**Southern Utah Fuel Company**

Enclosed are 13 copies of the update materials for the 4 East Ventilation Portal Breakout Amendment. The designs have been certified and the riprap design is included in the calculation sheets per your October 18, 1990 Conditional Approval Letter.

REVISED 4 EAST VENTILATION PORTALS

1. Replace 4 East Ventilation Portal text (2 pages) with new text (3 pages).
2. Replace Maps 1 and 2 with certified Maps 1 and 2.
3. Replace Map 3 dated February 17, 1988 with new Map 3 dated September 1990.
4. Add engineering calculation pages behind text.
5. Add 4 East Portal Drainage Basin Map, Map 4.

DATE	SEPT. 1990	SCALE	1" = 100'
DRAWN BY	S.K.S.	DRAWING NO.	MAP 3

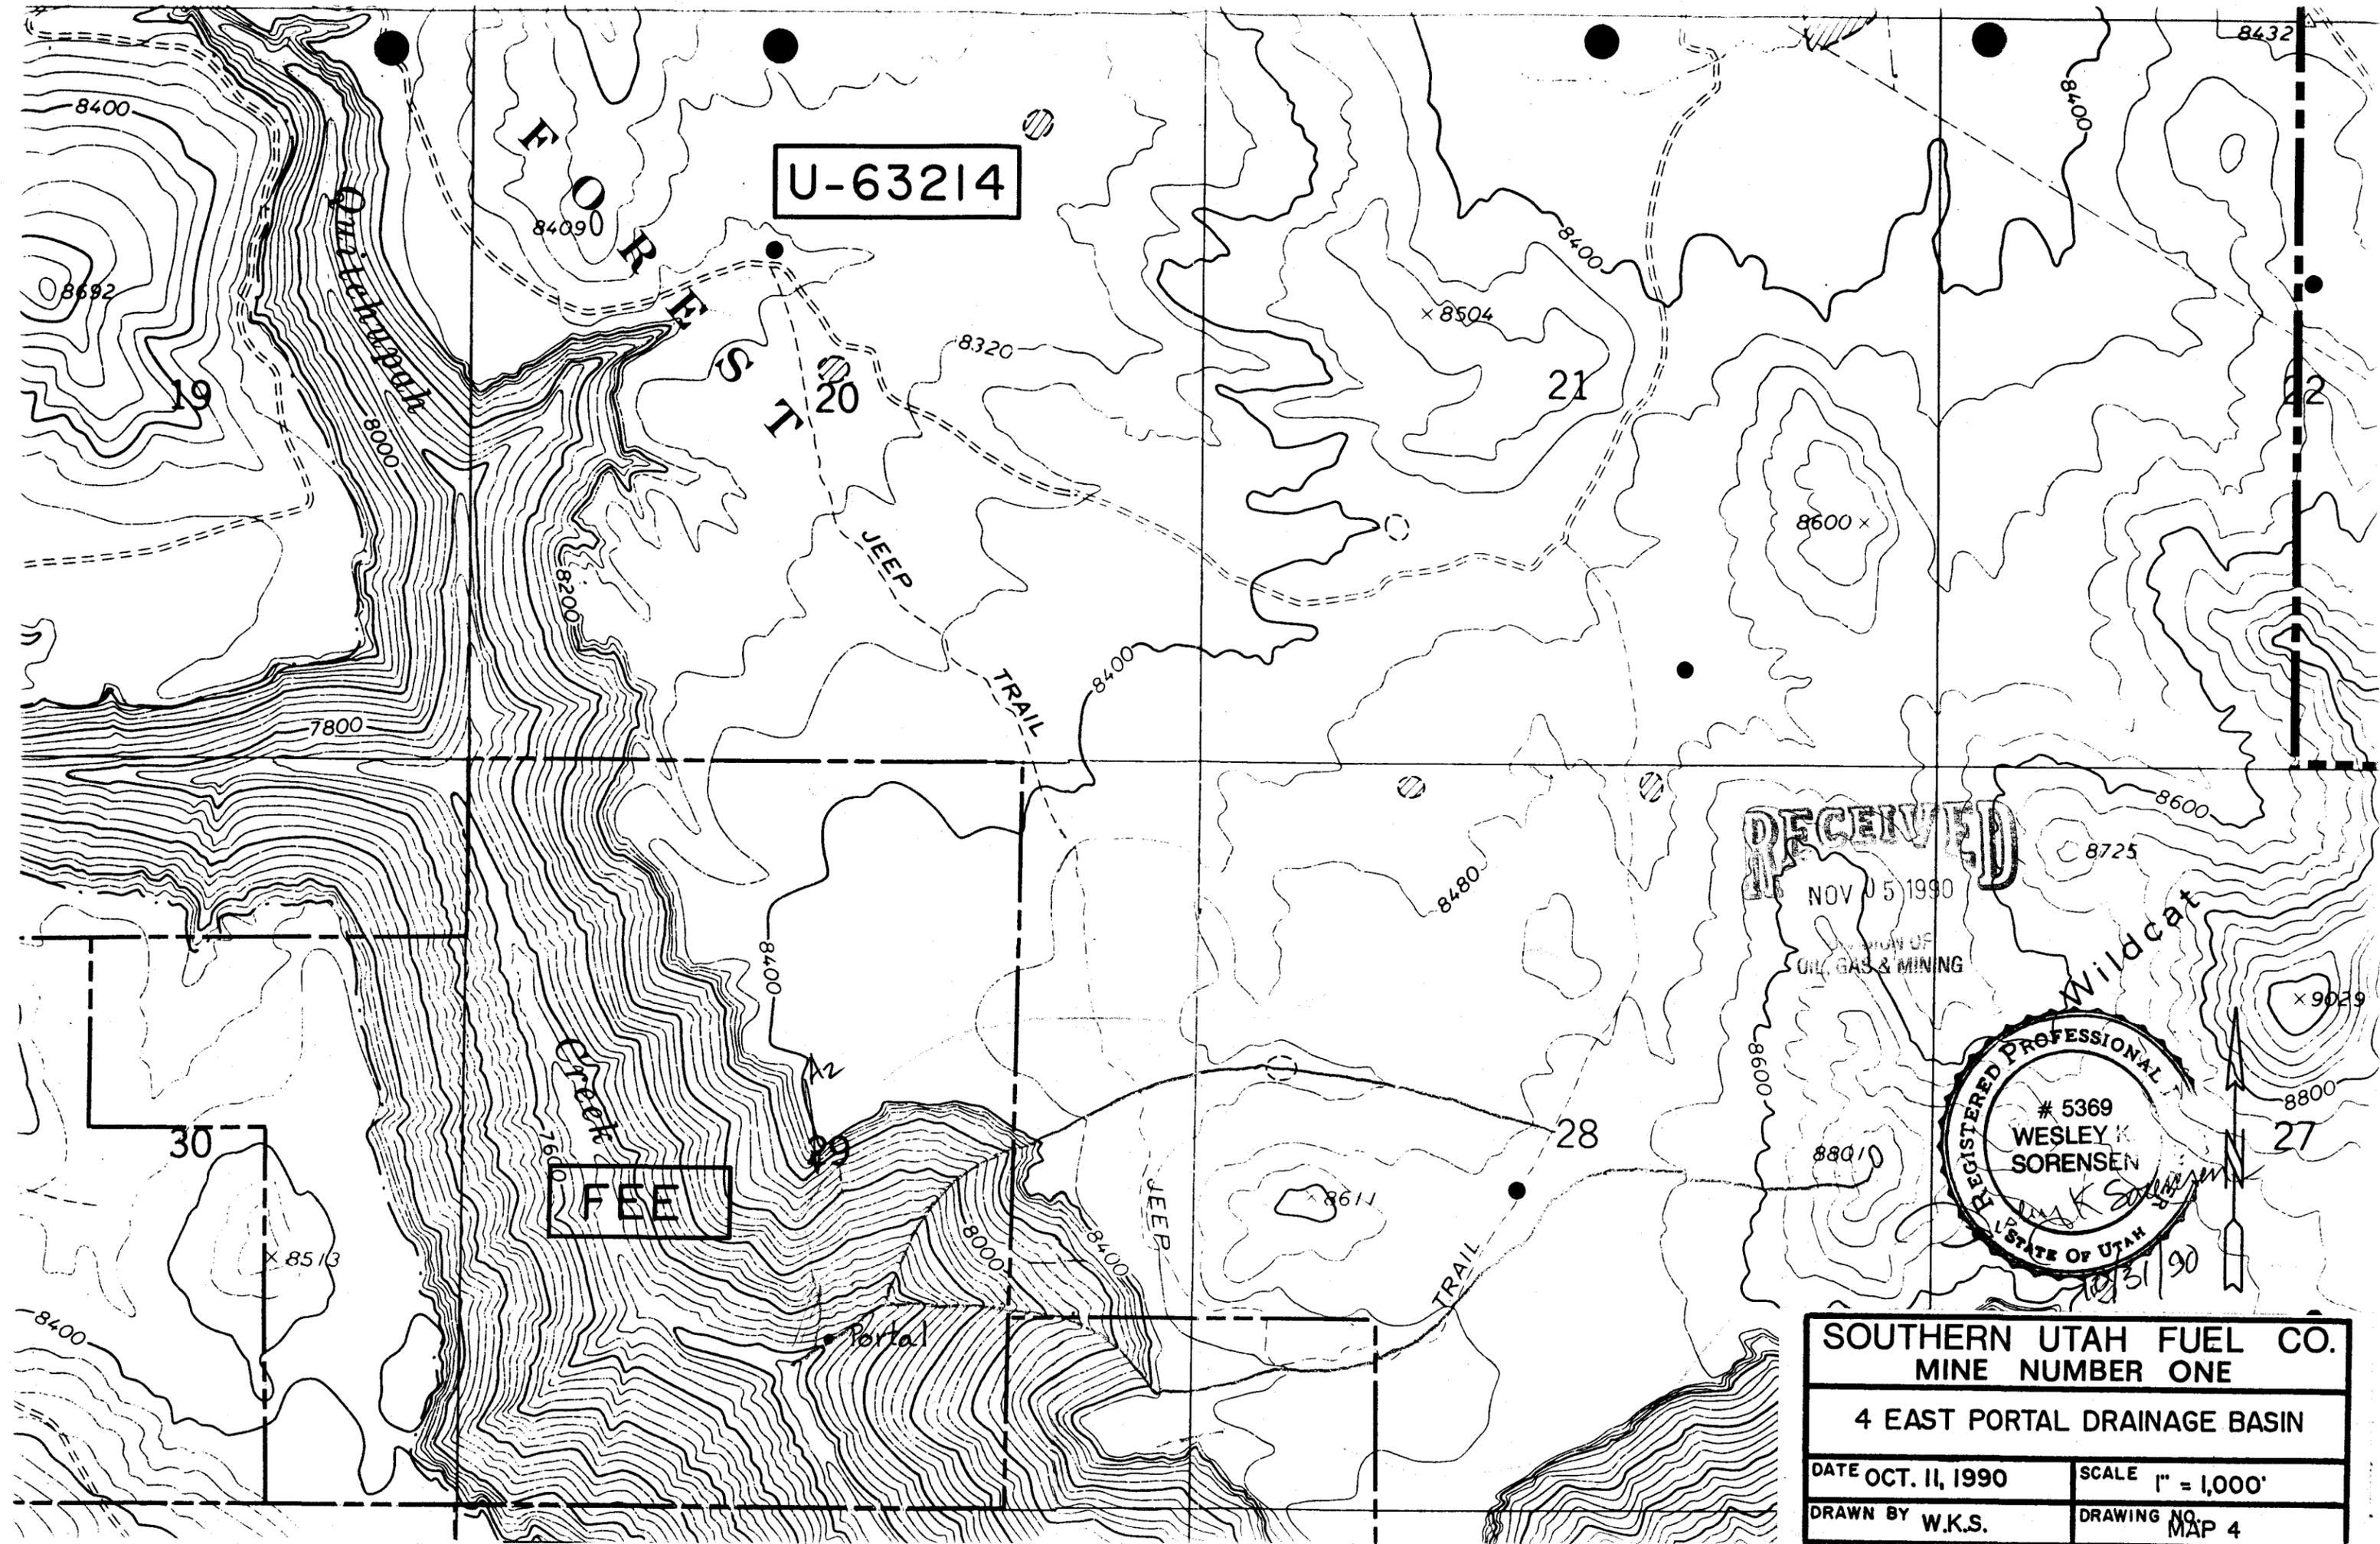
Two dry washes traverse through the proposed fan area as shown on Map 3. Runoff from precipitation events and snow melt in these washes will be by-passed through culverts. The 100 year 24-hour event for this area is 2.9 inches. This event was used to size the corrugated metal (CMP) pipe culverts. These culverts will have trash racks to prevent plugging.

72 in. BYPASS  
C.M.P.

24 in. BYPASS  
C.M.P.
